| Dist | COUNTY | ROUTE | POST MILES TOTAL PROJECT | SHEET No. | TOTAL SHEETS |
|---|---|---|---|---|---|
| 12 | Ora | 1 | 22.0/29.9 | 54 | 126 |

1 **REPLACED PER ADDENDUM No. 1 DATED SEPTEMBER 15, 2016**

# MODIFYING EXISTING ELECTRICAL SYSTEM

**E-3**

**E-5**

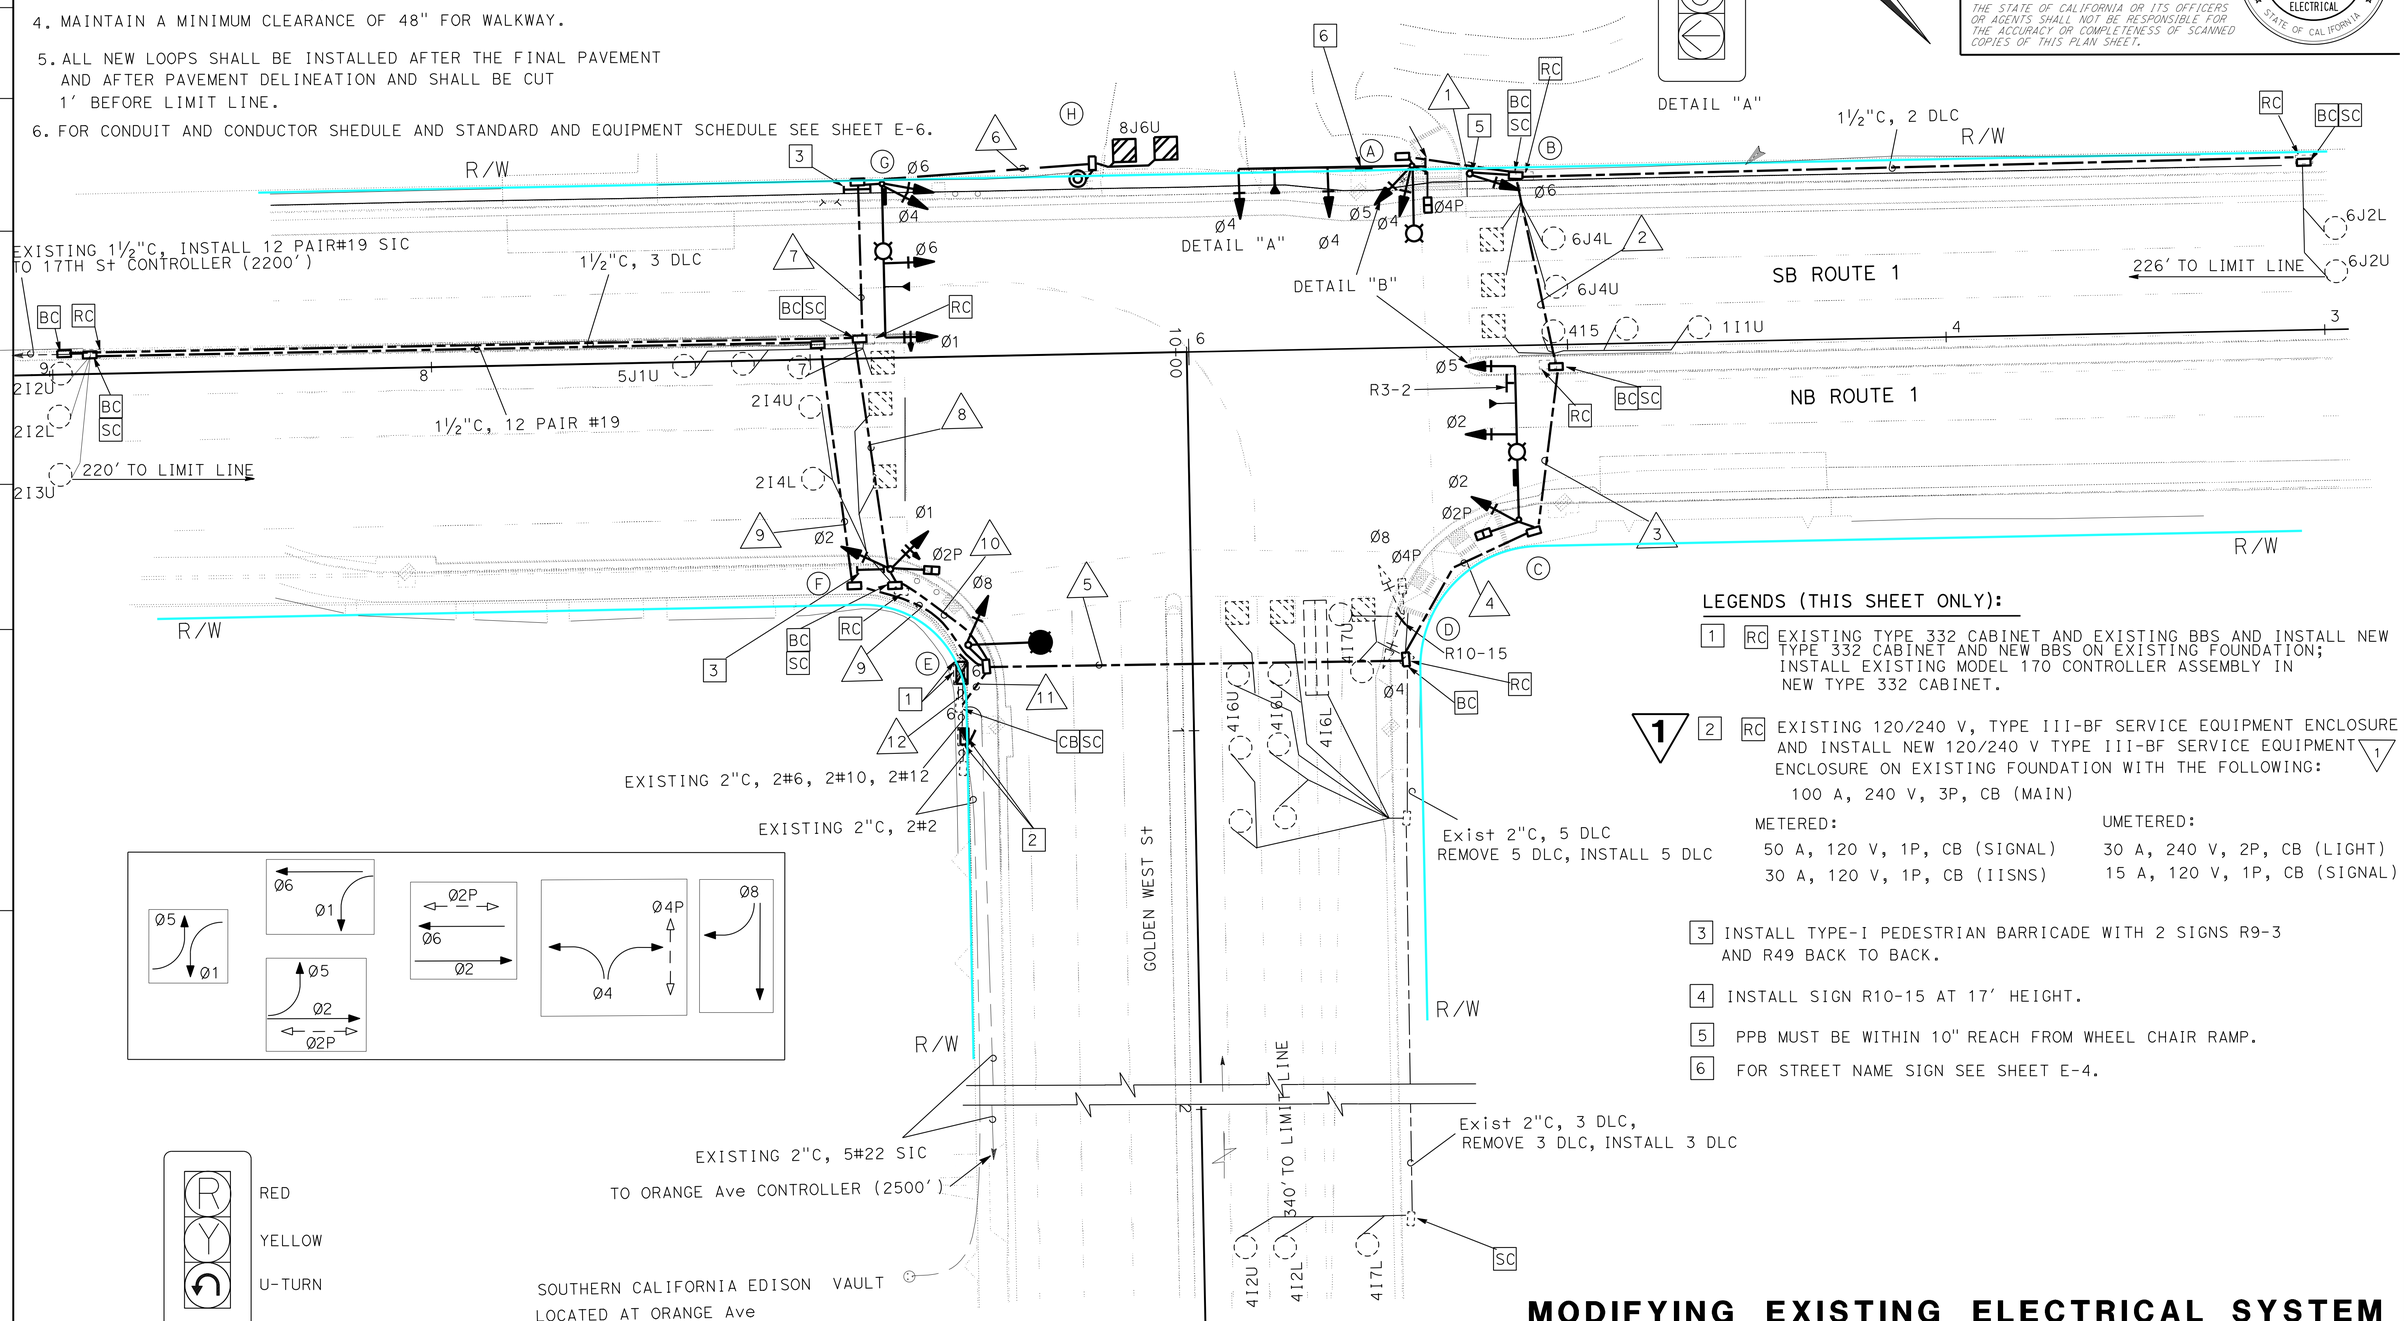
1 2 RC EXISTING 120/240 V, TYPE III-BF SERVICE EQUIPMENT ENCLOSURE AND INSTALL NEW 120/240 V TYPE III-BF SERVICE EQUIPMENT ENCLOSURE ON EXISTING FOUNDATION WITH THE FOLLOWING: 1

1 **REPLACED PER ADDENDUM No. 1 DATED SEPTEMBER 15, 2016**

100 A, 240 V, 3P, CB (MAIN)

| METERED: | UMETERED: |
| 50 A, 120 V, 1P, CB (SIGNAL) | 30 A, 240 V, 2P, CB (LIGHT) |
| 30 A, 120 V, 1P, CB (IISNS) | 15 A, 120 V, 1P, CB (SIGNAL) |

**E-8**

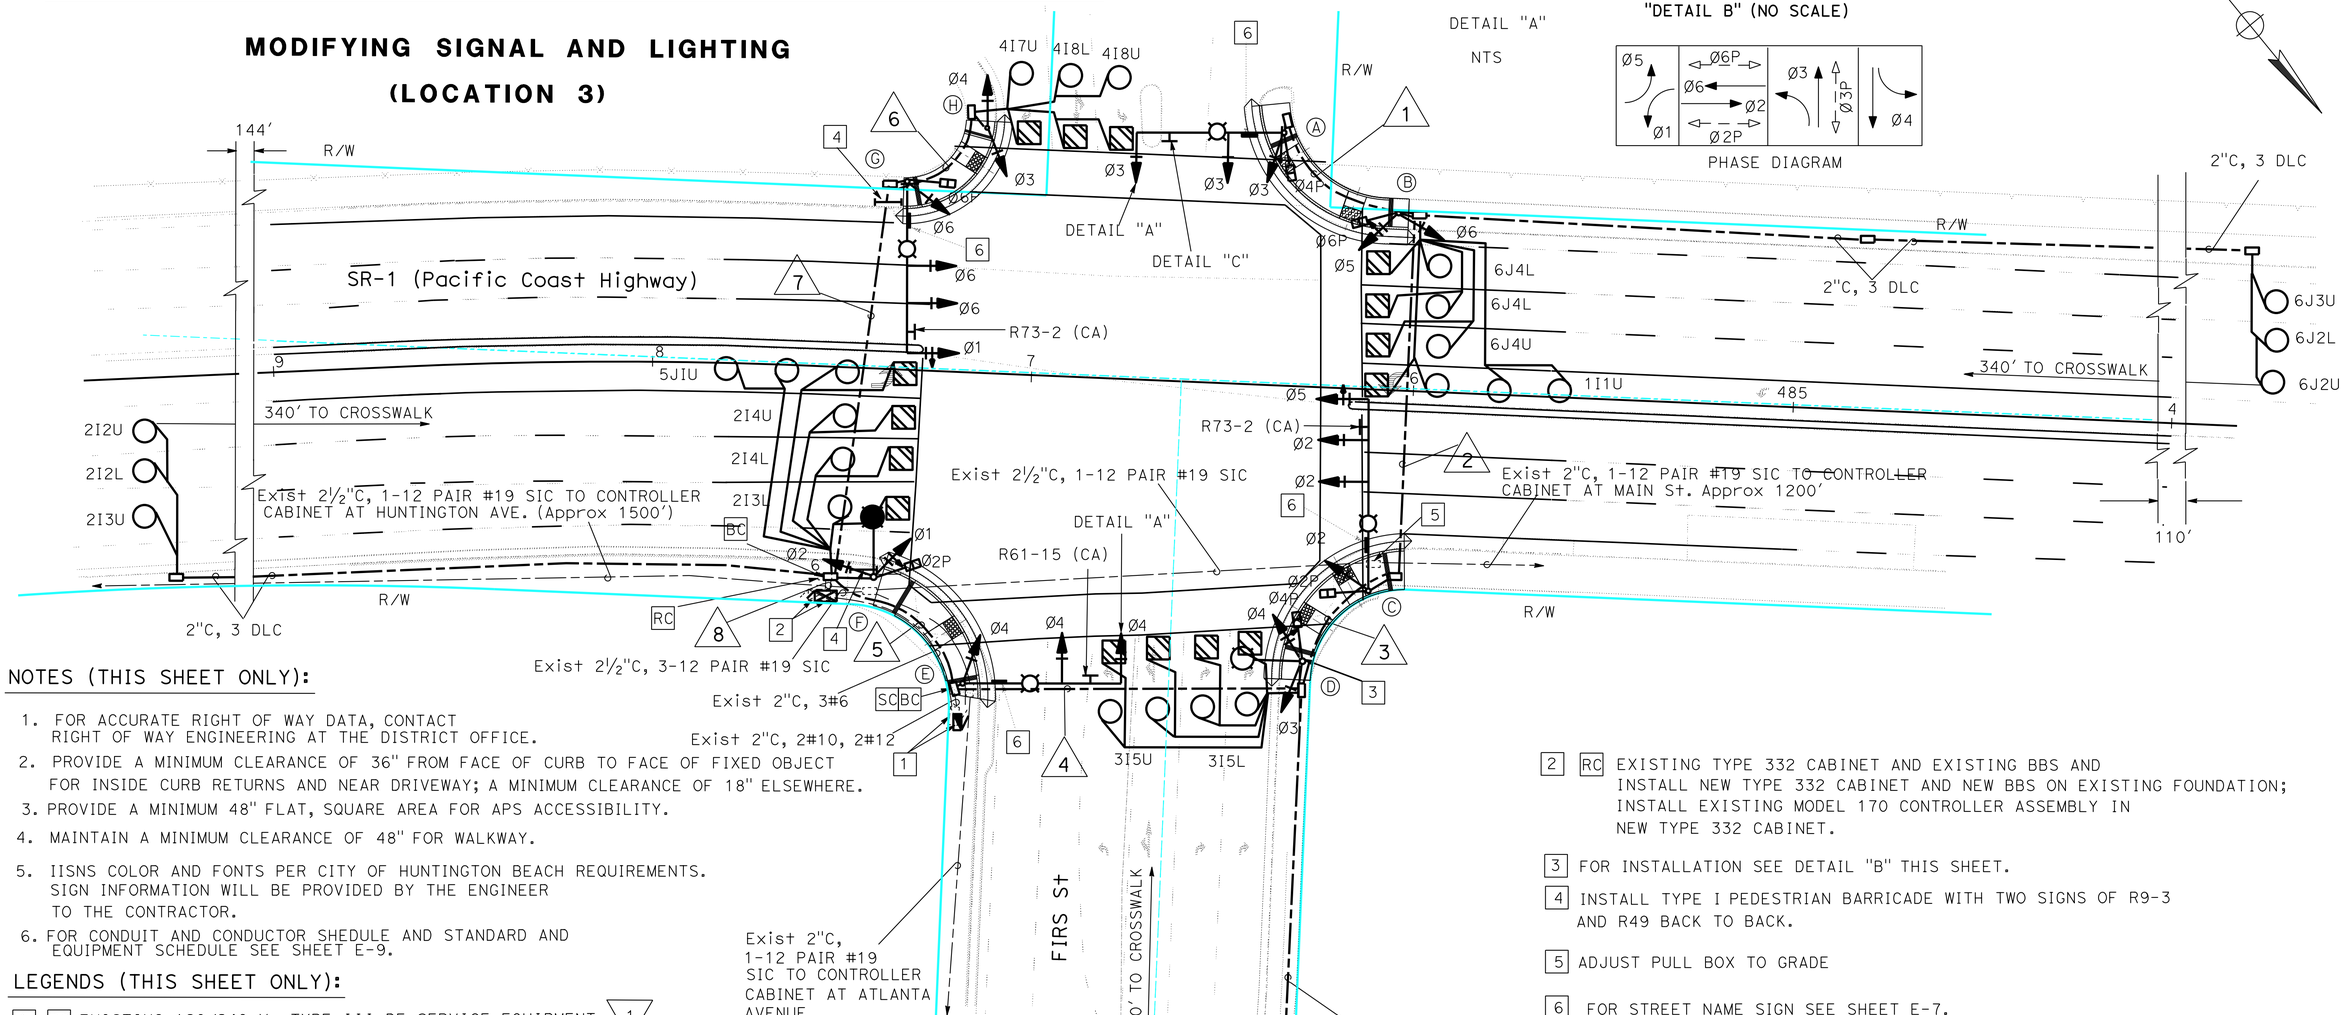
1 RC EXISTING 120/240 V, TYPE III-BF SERVICE EQUIPMENT ENCLOSURE AND INSTALL NEW 120/240 V TYPE III-BF SERVICE EQUIPMENT ENCLOSURE ON EXISTING FOUNDATION WITH THE FOLLOWING: (1)

(1) **REPLACED PER ADDENDUM No. 1 DATED SEPTEMBER 15, 2016**

METERED:
- 100 A, 240 V, 3P, CB (MAIN)
- 50 A, 120 V, 31P, CB (SIGNAL)
- 20 A, 120 V, 1P, CB (IISNS)

UNMETERED:
- 30 A, 120 V, 1P, CB (LIGHTING)
- 15 A, 120 V, 1P, CB (PEC)

**E-10**

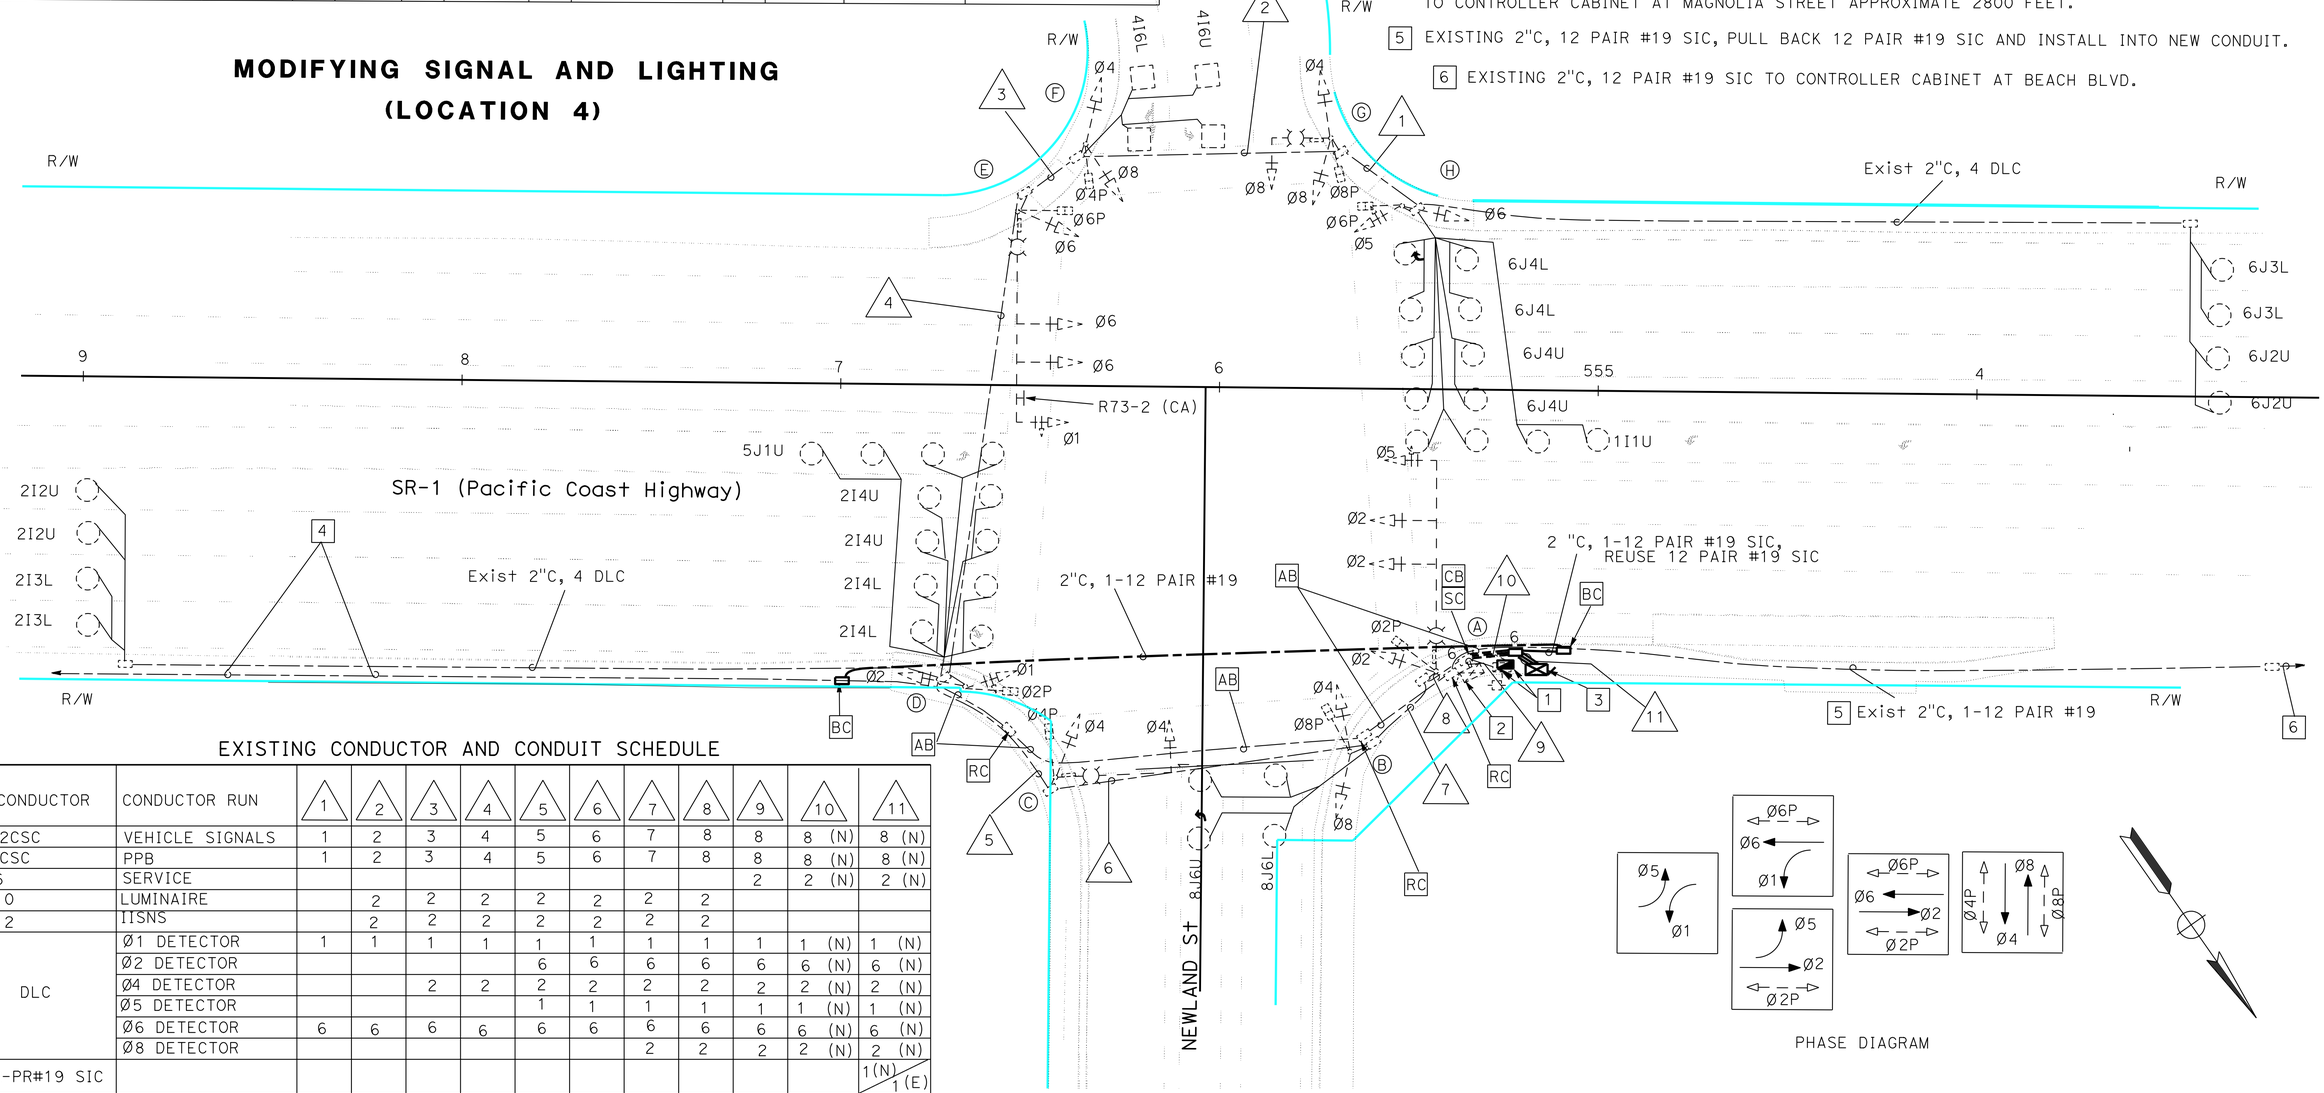
1 **REPLACED PER ADDENDUM No. 1 DATED SEPTEMBER 15, 2016**
*APPROVED FOR ELECTRICAL WORK ONLY*

**E-17A**

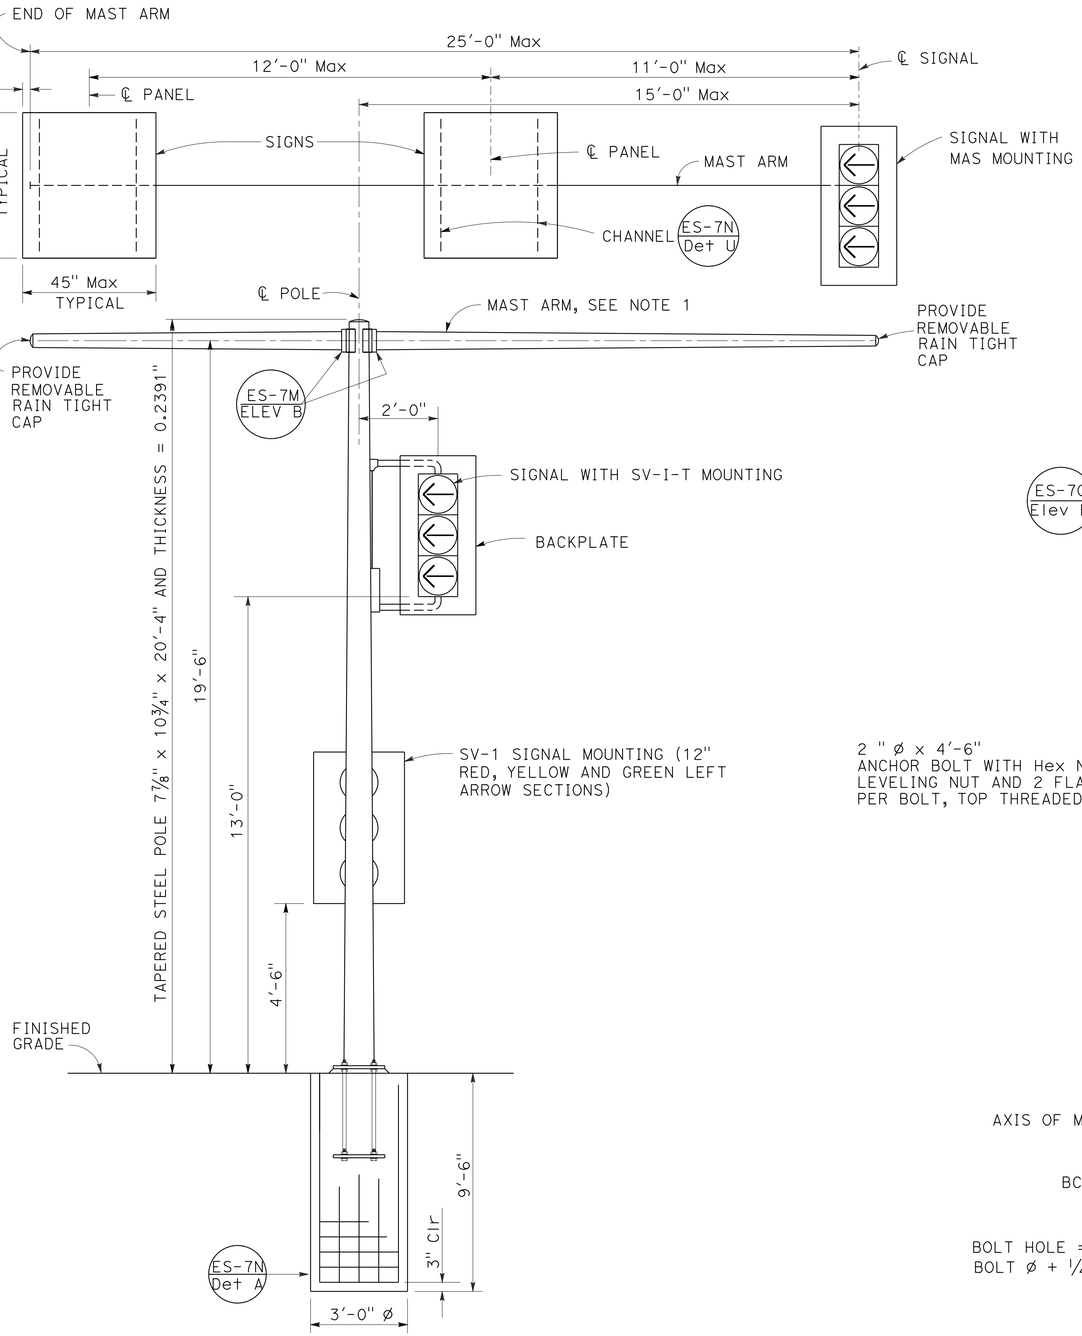
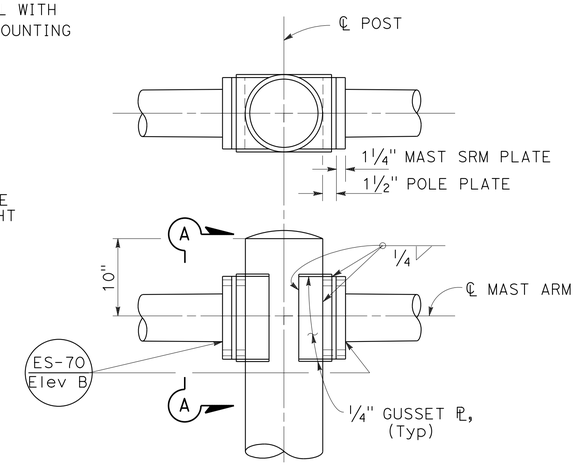
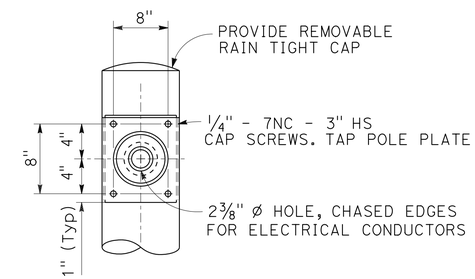
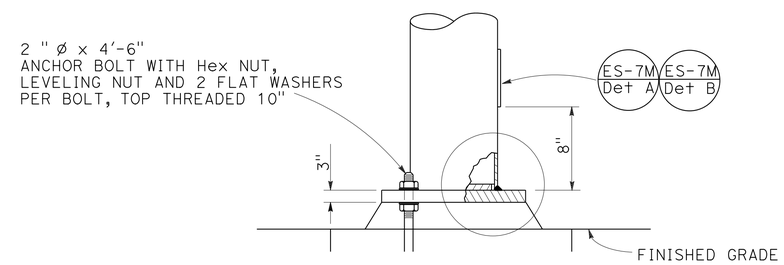
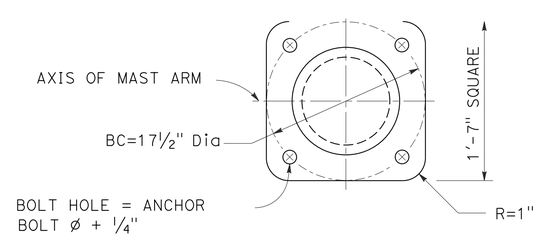
1 **ADDED PER ADDENDUM No. 1 DATED SEPTEMBER 15, 2016**
